Re: Marlboro Road Culvert Replacement NOI
Response to Comments

TOWN OF SUDBURY, MA MARLBORO ROAD CULVERT REPLACEMENT

PROJECT NO. 227202.06

SEDIMENT BARRIER - SILT FENCE

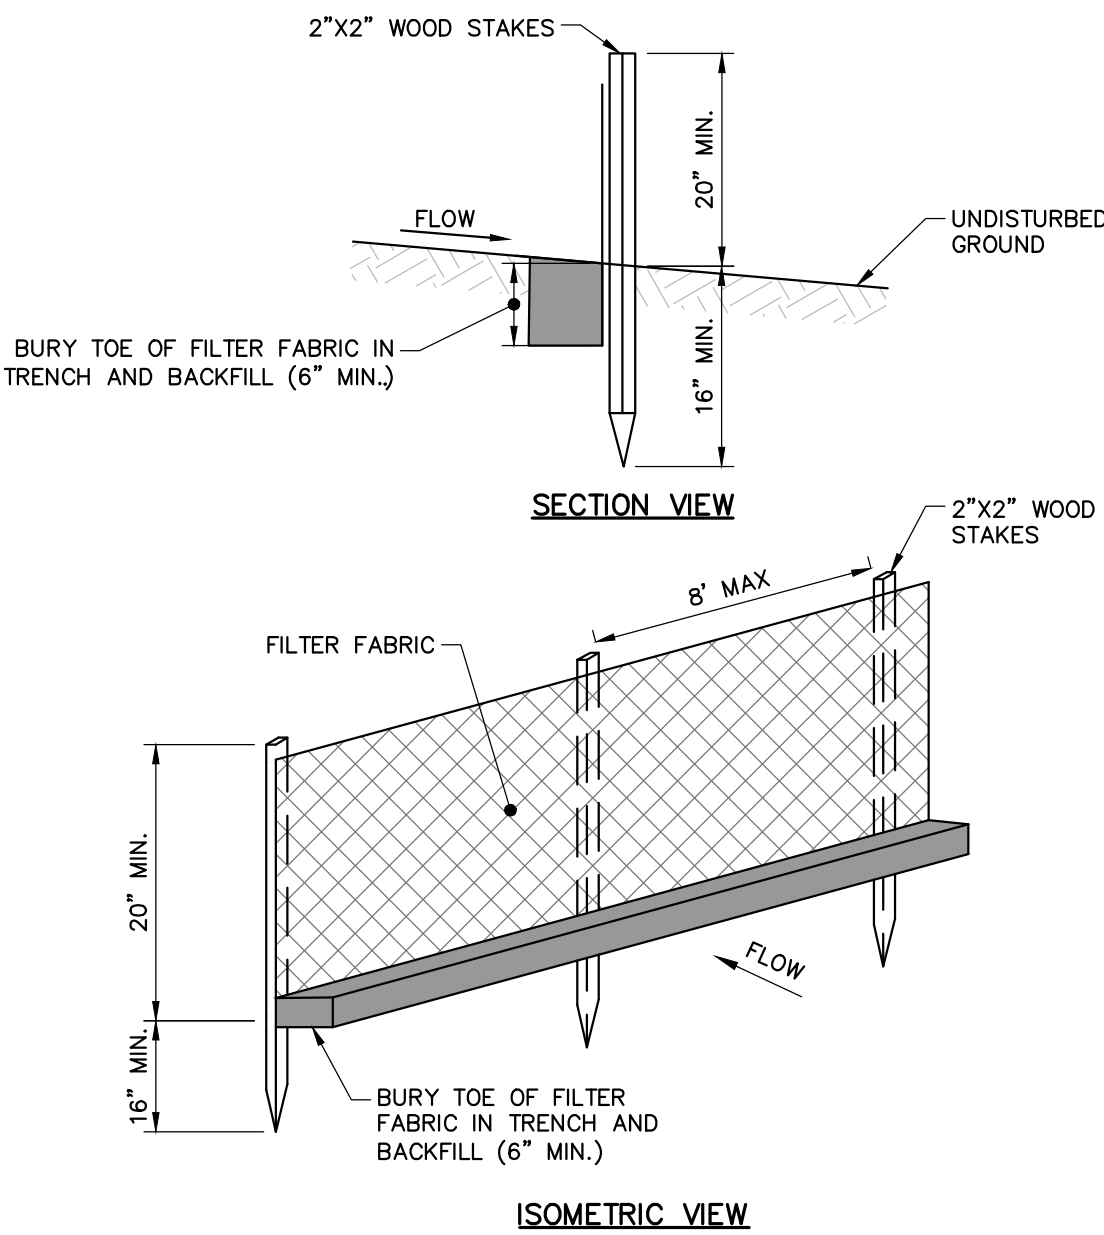
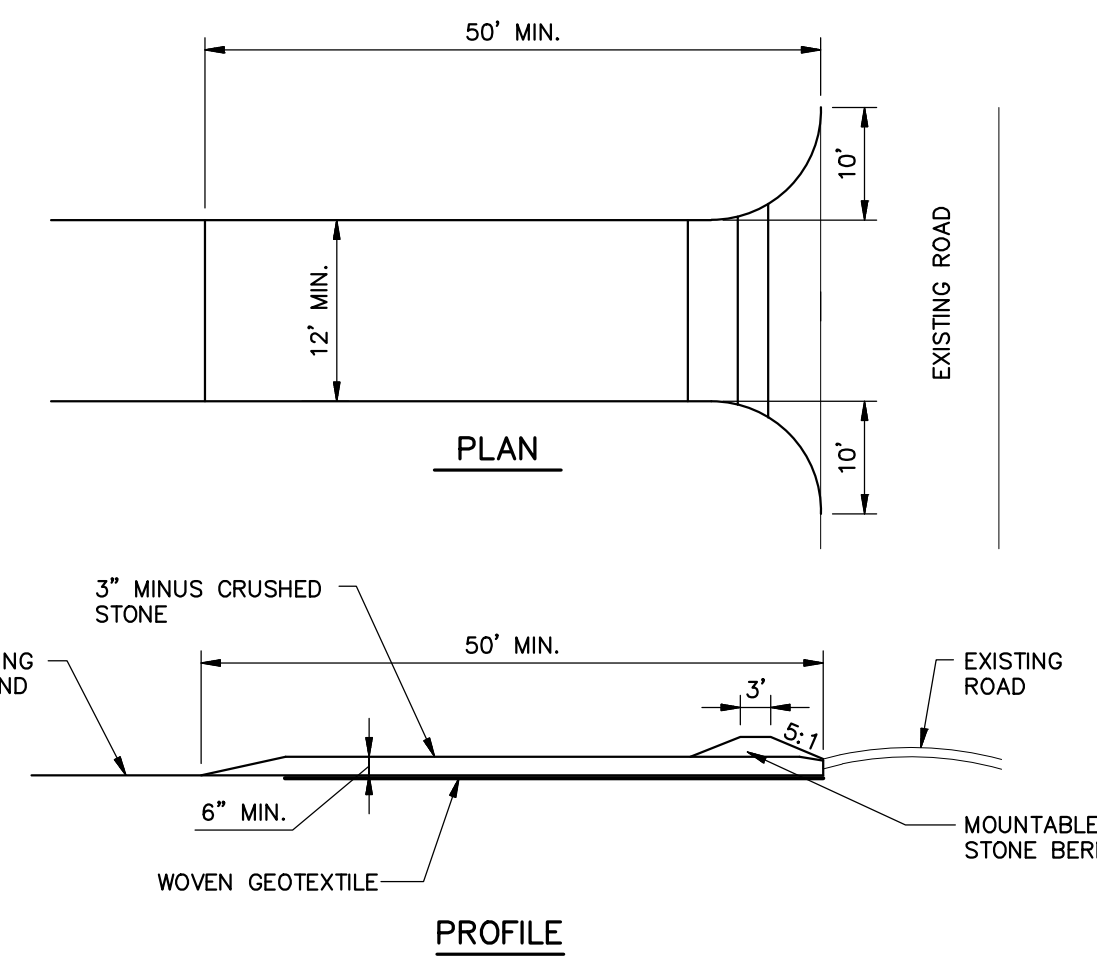
- 7. Remove "Contractor Option" from erosion control details. Plan/Order dictates erosion controls needed, which the contractor can request to modify later, but it should not be left to their own discretion.

- *We have removed "Contractor Option" from the erosion control details.*
- 8. Note native seed mixes that should be used.
 - *A native seed mix specification has been added to the notes and callouts on sheet C-102. Native wildflower see mix shall be New England Environmental Conservation/Wildlife mix, or similar. Native wetland see mix shall be New England Erosion Control/Restoration mix for detention basins and moist sites.*

RIPRAP SLOPE DETAIL

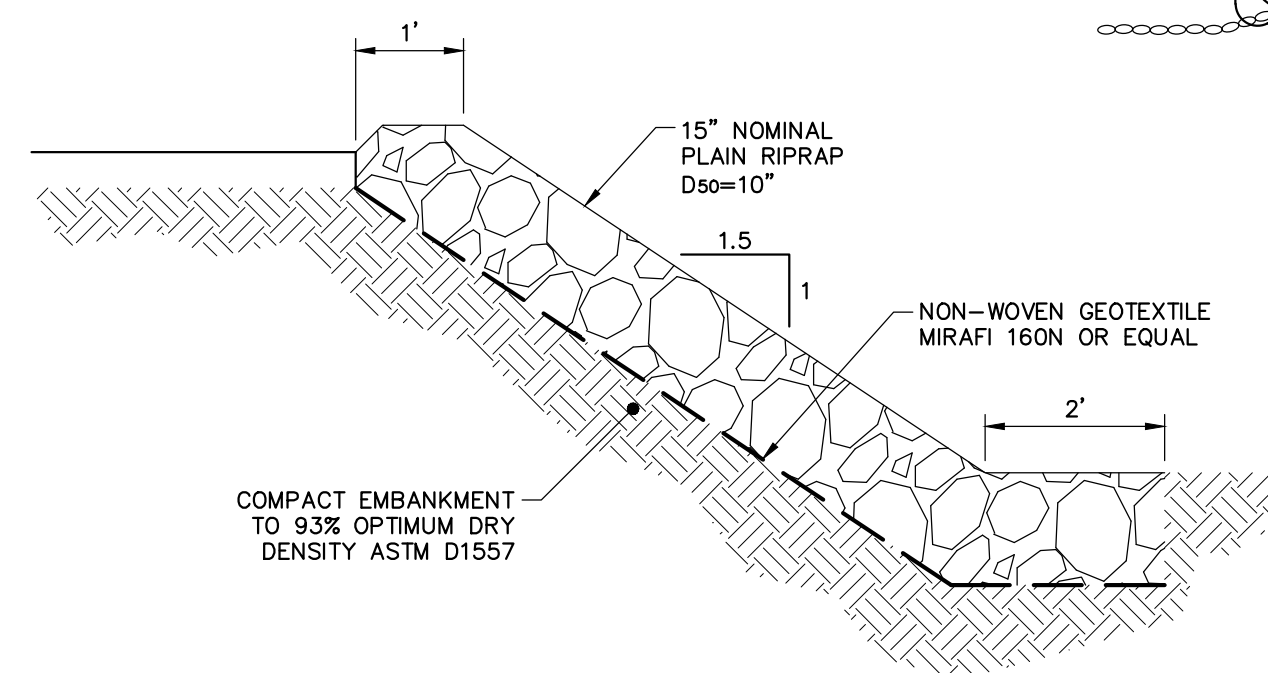
- 4. Is the riprap behind the upstream headwall needed or can this be vegetated?
 - *Due to the slope of this area, we are recommending the small amount (approximately 146 SF) of riprap.*
